**ADDENDUM
NO. 1**

March 3, 2021

Scott County School District 1 – Austin Elementary Additions & Renovations and HS Pool Renovation
Austin, IN 47102

ADDENDUM NO. ONE

1 ENLARGED PLUMBING PLAN
1/4" = 1'-0"

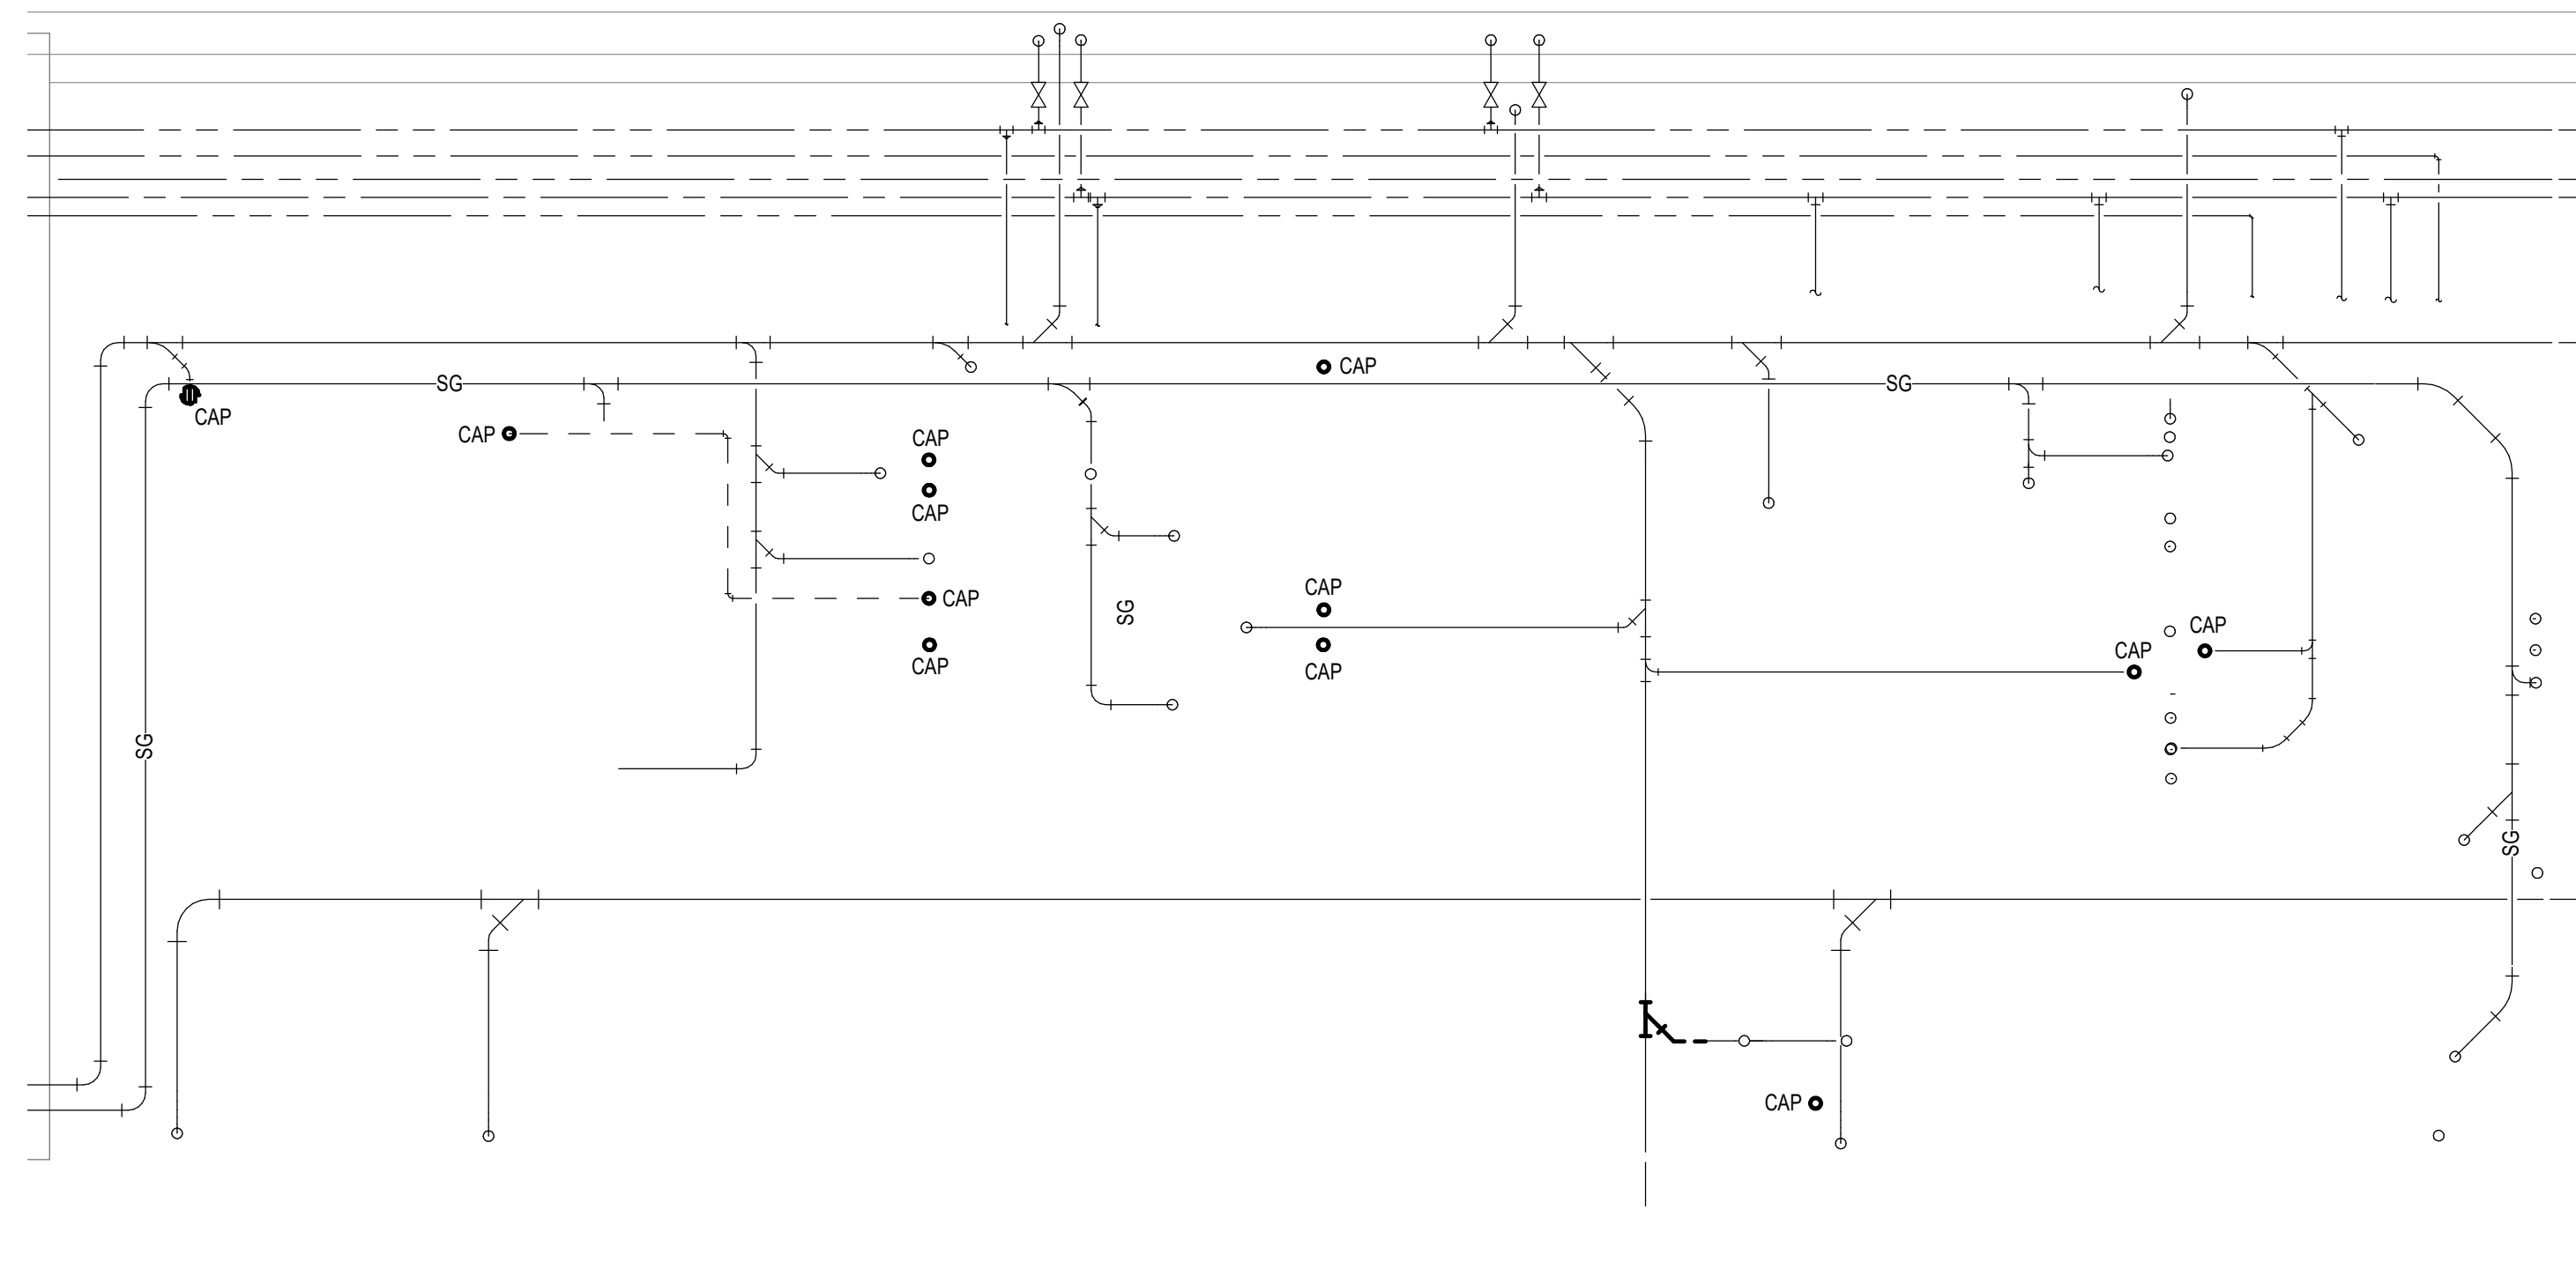
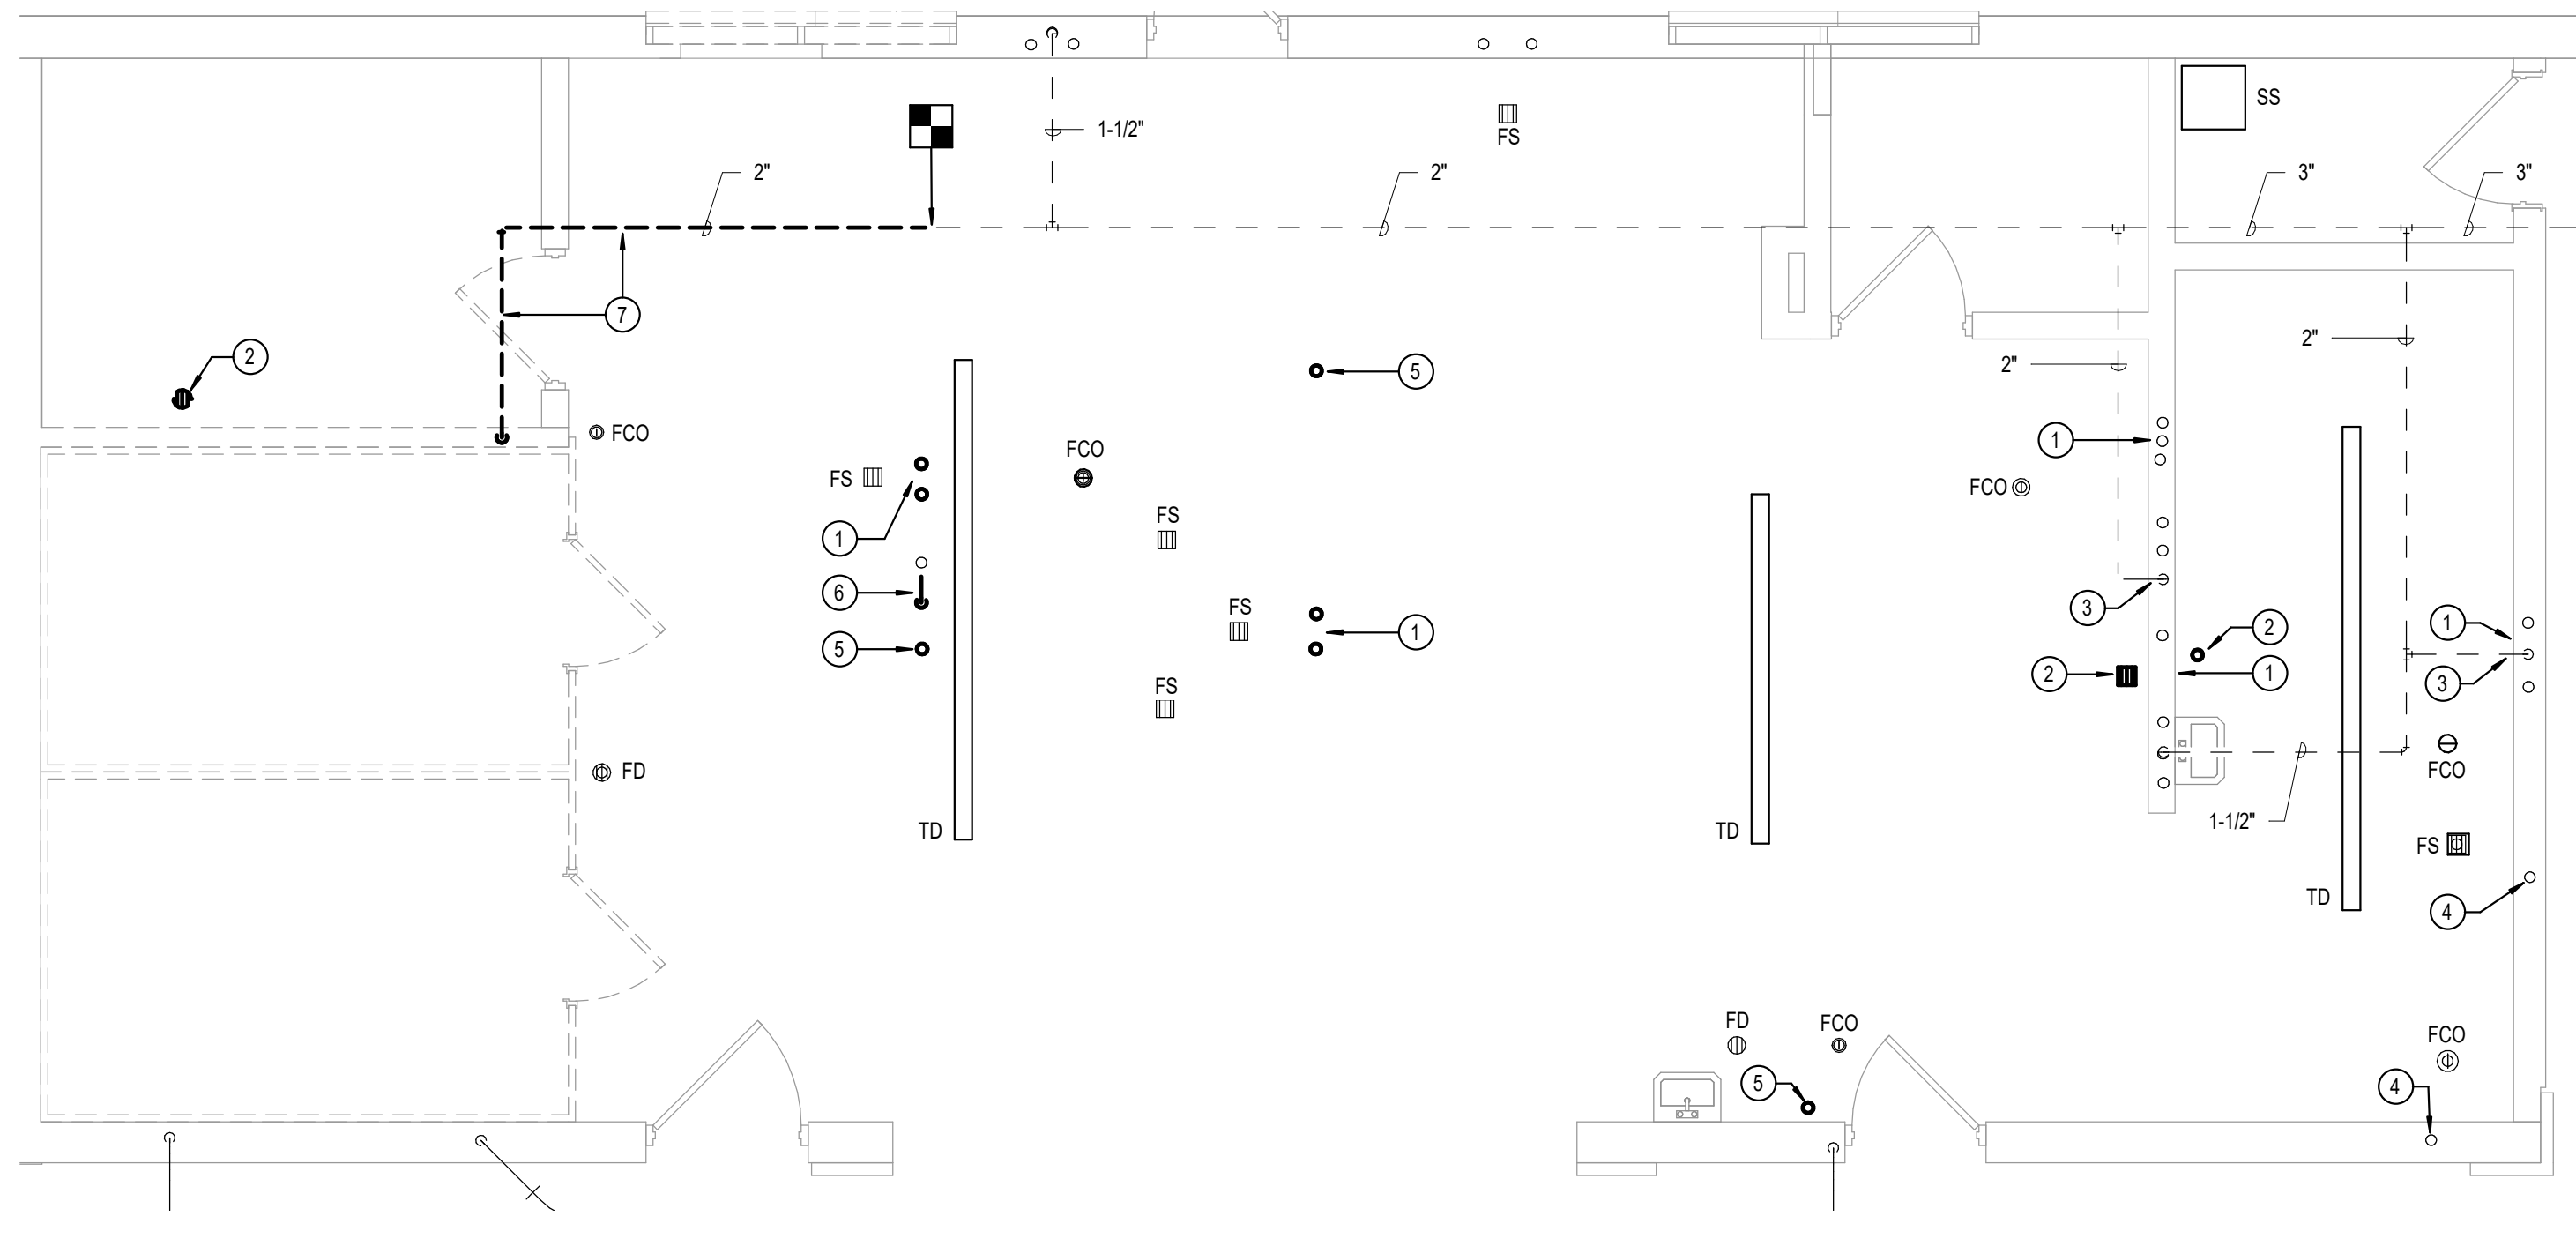
5. Drawing No.: P401
Drawing Sheet Title: ENLARGED PLUMBING PLANS
Revision: Add domestic cold water, domestic hot water, and domestic hot water return lines to serve the Kitchen. See attached drawing.

6. Drawing No.: P402
Drawing Sheet Title: ENLARGED PLUMBING PLANS
Revision: Add plumbing scope associated with the Kitchen area. See attached drawing.
7. Drawing No.: P601
